AMENDMENT TO PROJECT AGREEMENT

Project Amendment Number: 20-000029.1

Project Name: ROUND ROCK Behrens Ranch Park

Wildlife Division Resource Review Comments

Project Boundary Map
Round Rock Behrens Ranch Park
20-000029 (as amended)

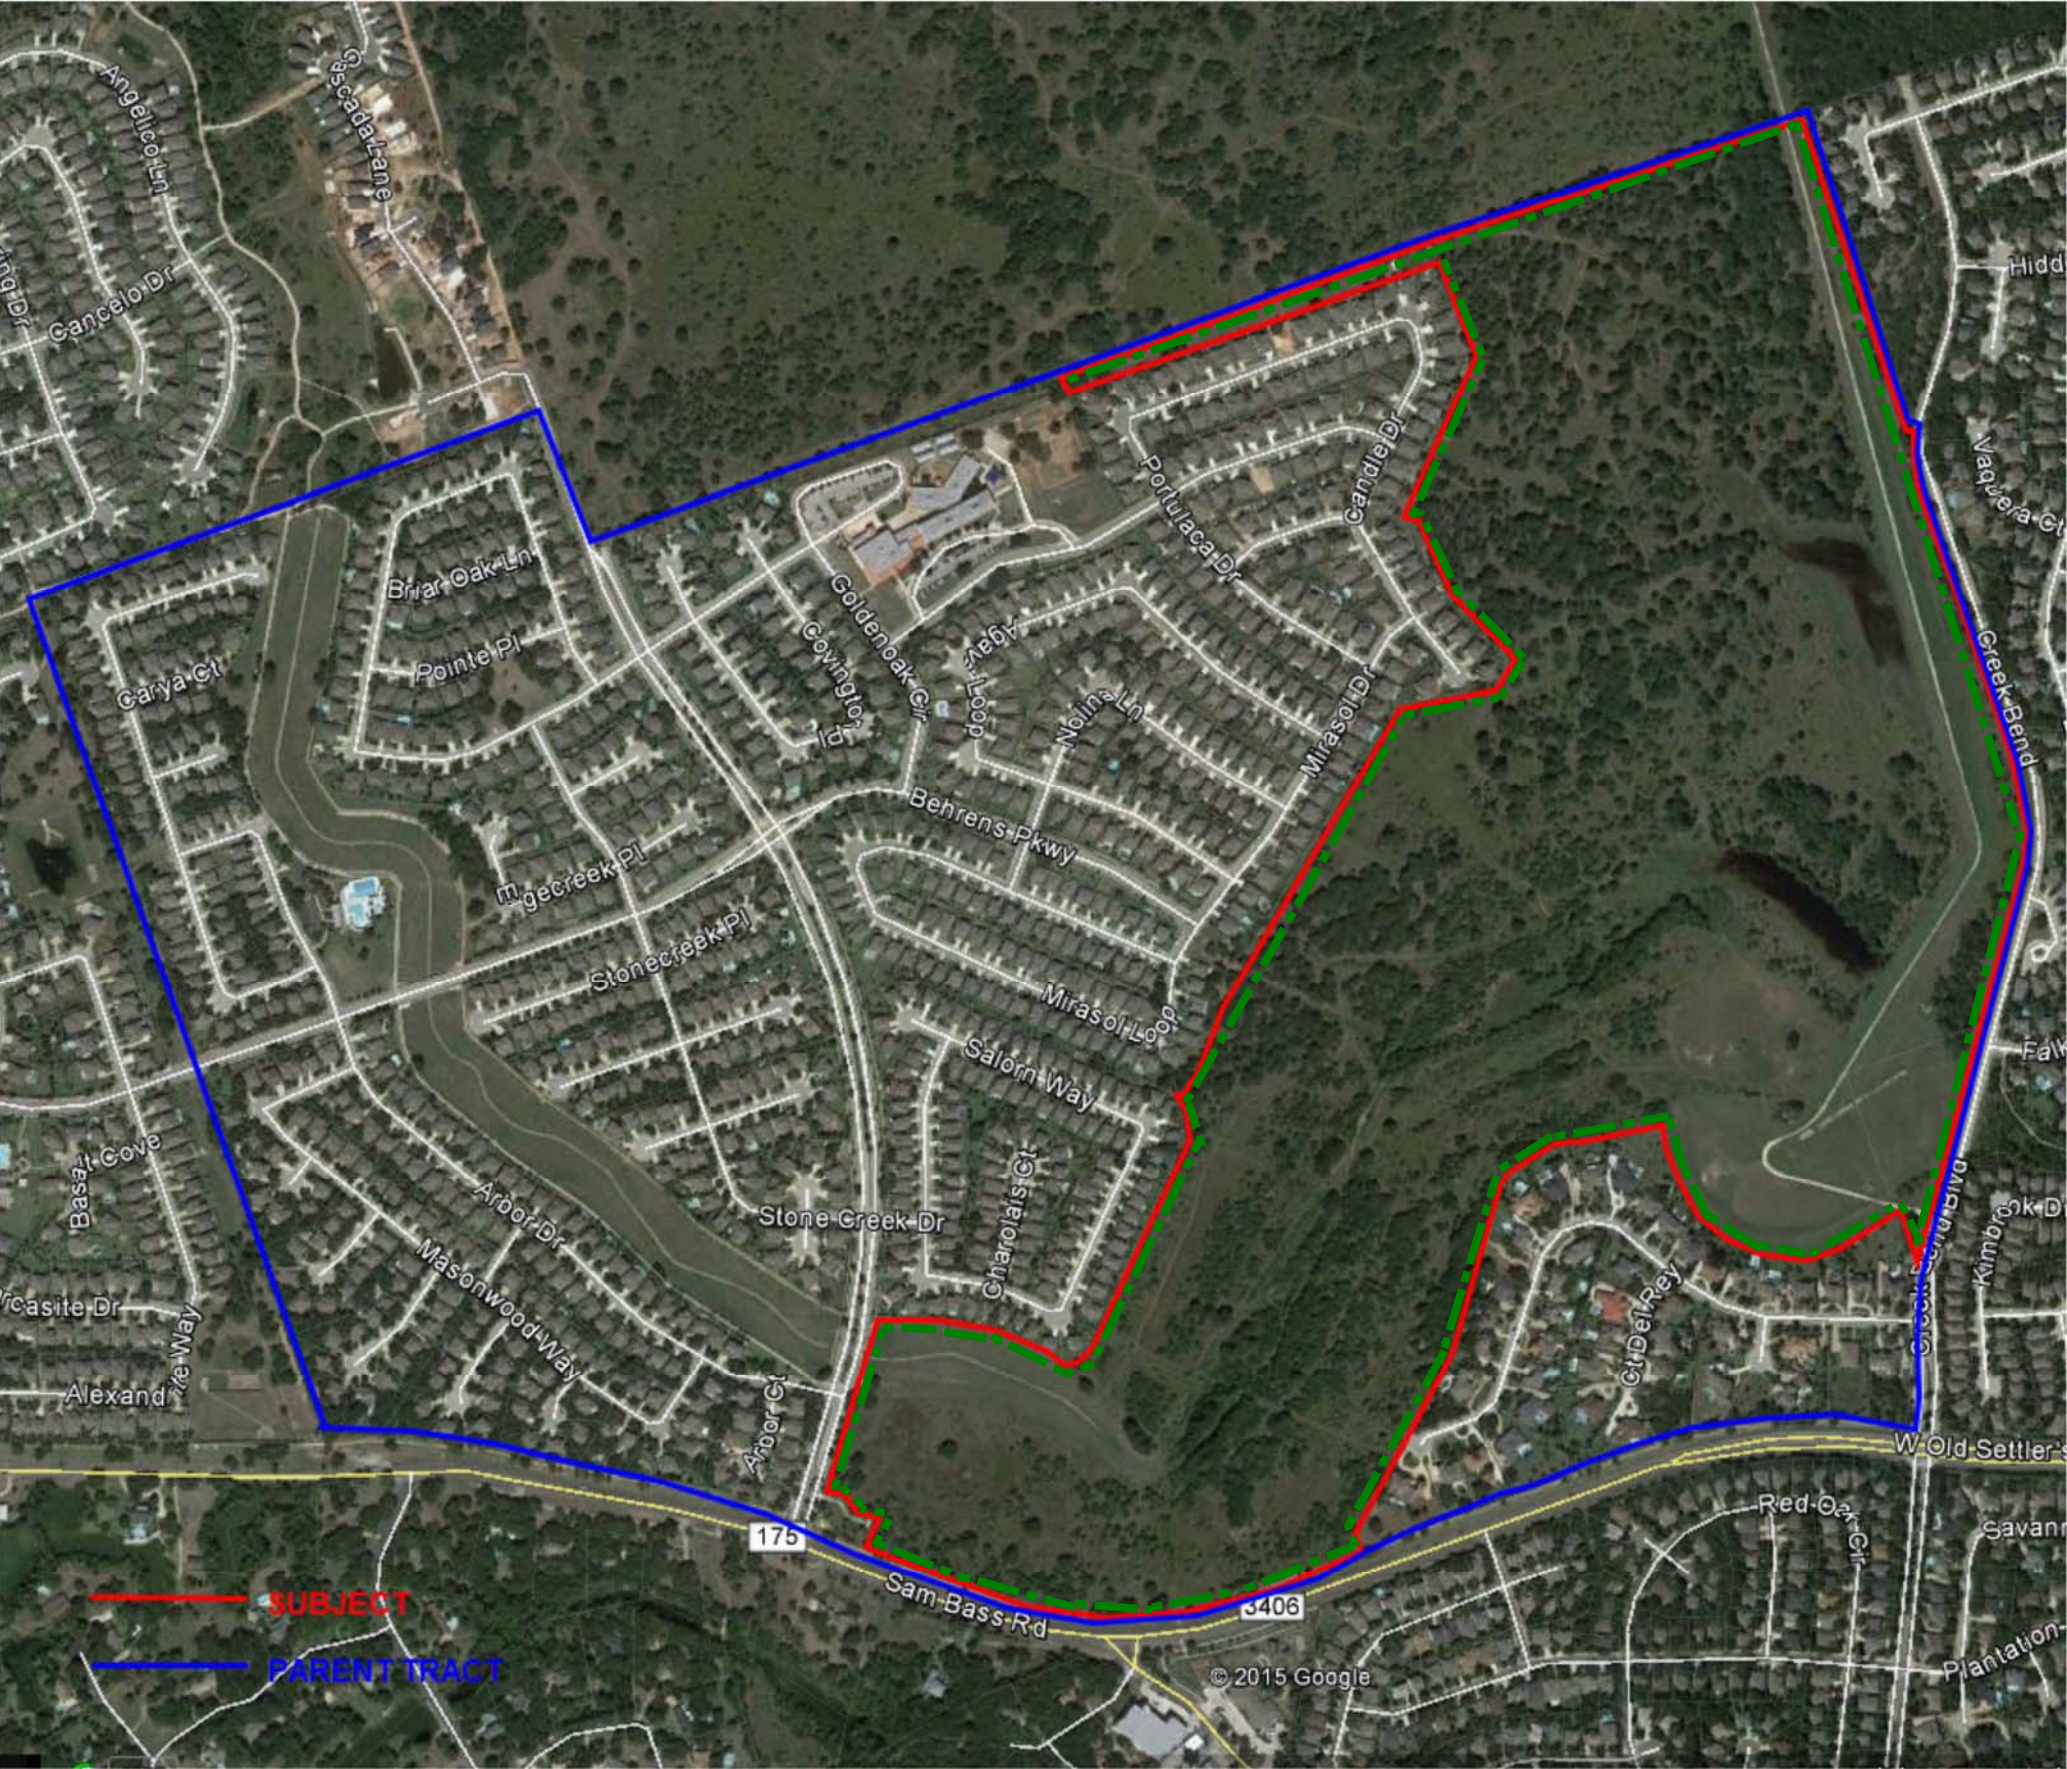
To **DELETE** by conversion the 18.414 acre McNeil Park from the project scope.

To **REPLACE** the converted site with the 226.03 acre site located along the north line of Sam Bass Road/FM 3406 and the west line of Creek Bend Blvd., Round Rock, Williamson County, Texas.
